**Town of Rotterdam
Planning Commission
October 21, 2025**

1. **Ridgeback Hospitality, LLC – 1809 - 1813 & 1821 Altamont Avenue & 1660 Elizabeth Street.** Concept Site Plan/Special Use Permit/Consolidated Subdivision for a $\pm 2,400$ square foot quick serve restaurant and a ± 531 square foot coffee shop both with a drive-thru on a $\pm 46,000$ square foot consolidated parcel. Engineer: Bohler Engineering.

3. **Peter Road, LLC – 759 Peter Road.** Preliminary Site Plan Review to construct 16 condominiums (four building containing 4 units each) on a ± 2.41 -acre parcel. Engineer: Steenburgh Consulting Engineering, PLLC.

3. **Peter Road, LLC – 759 Peter Road.** Preliminary Site Plan Review to construct 16 condominiums (four building containing 4 units each) on a ±2.41-acre parcel. Engineer: Steenburgh Consulting Engineering, PLLC.

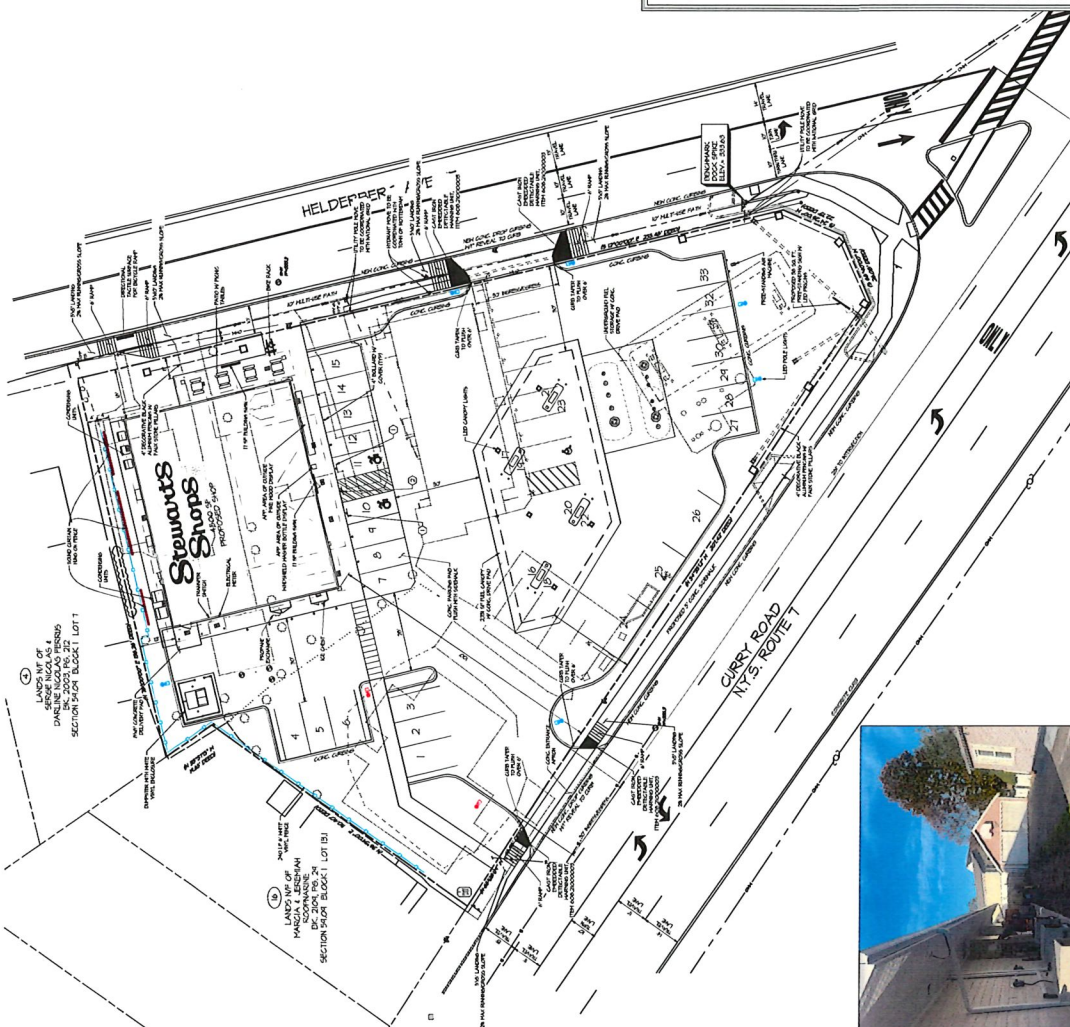
All items are in the correct location as shown on the proposed plan, including the building, but in reality the area behind our building is tight.

I wanted to see if the Board had any issue with us eliminating the 4' fence and shifting the 6' fence closer to our building. There is approximately 10' from the concrete pad behind our building to the neighbor's driveway. We would look to split that difference and install the 6' fence approximate 5' off our concrete and then install the sound blankets on this fence.

This fence location would also allow for additional snow storage for the neighbor and not have them hampered with a fence tight against their driveway.

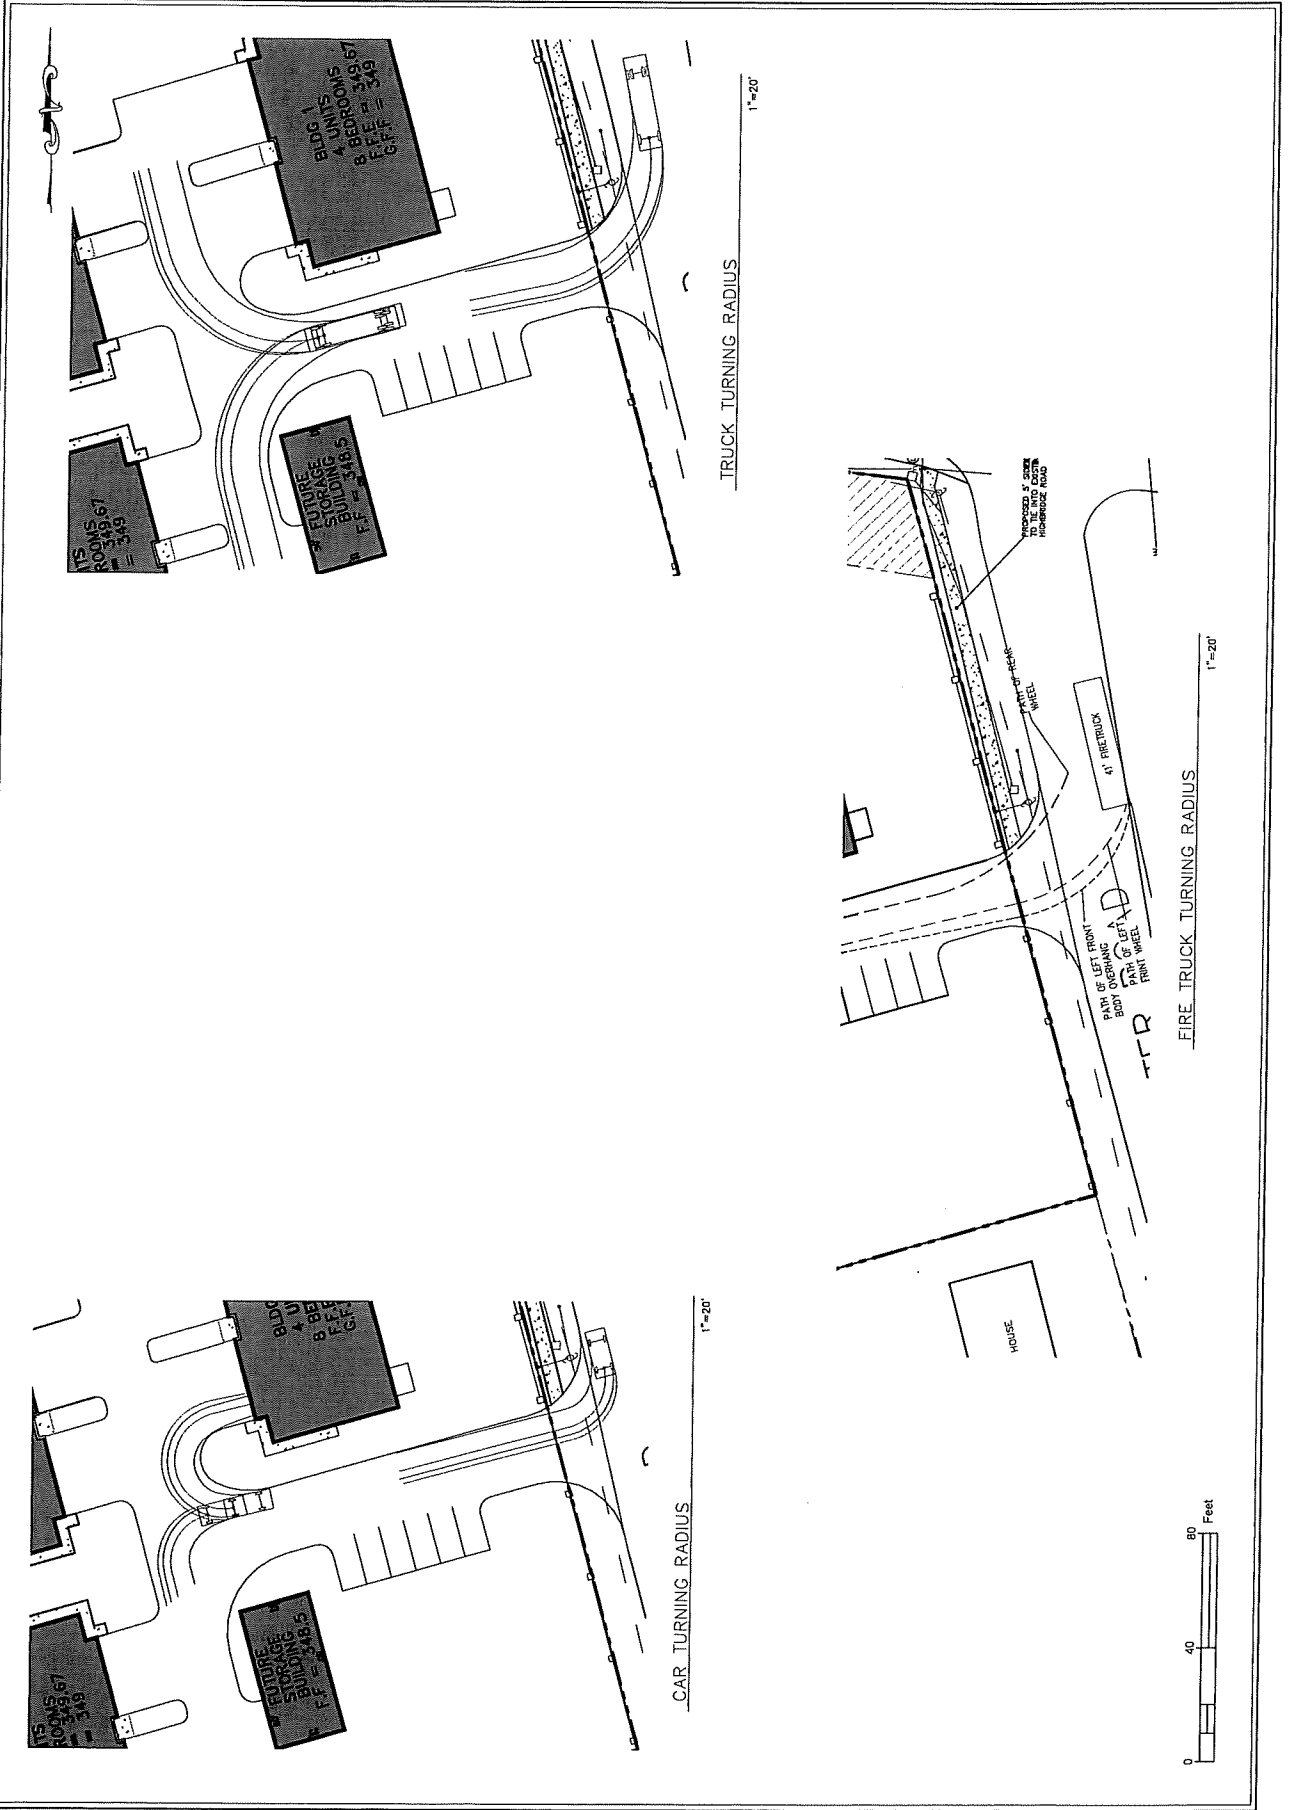
13. Provide truck turning movement to confirm acceptable emergency service vehicle access and circulation.

16. A utility pole is just 3'-6" from edge of pavement within the entrance radius and it does not appear curbing is proposed, making this pole a potential hazard. There is the possibility that delivery trucks (FedEx, UPS, etc.) or other occasional larger vehicles will hit this utility pole while turning because of the lack of clear zone. Applicant should verify that a delivery truck can make this turn reasonably without hitting the pole. It may still get hit "in real life" with spacing that small, but it should at least be shown on paper with a truck template that it can be done without encroaching into the exiting lane of traffic.

Turning movements for trucks, cars and fire trucks have been added in a separate sheet.

A truck turning template has been shown to show that a truck can make this turn.
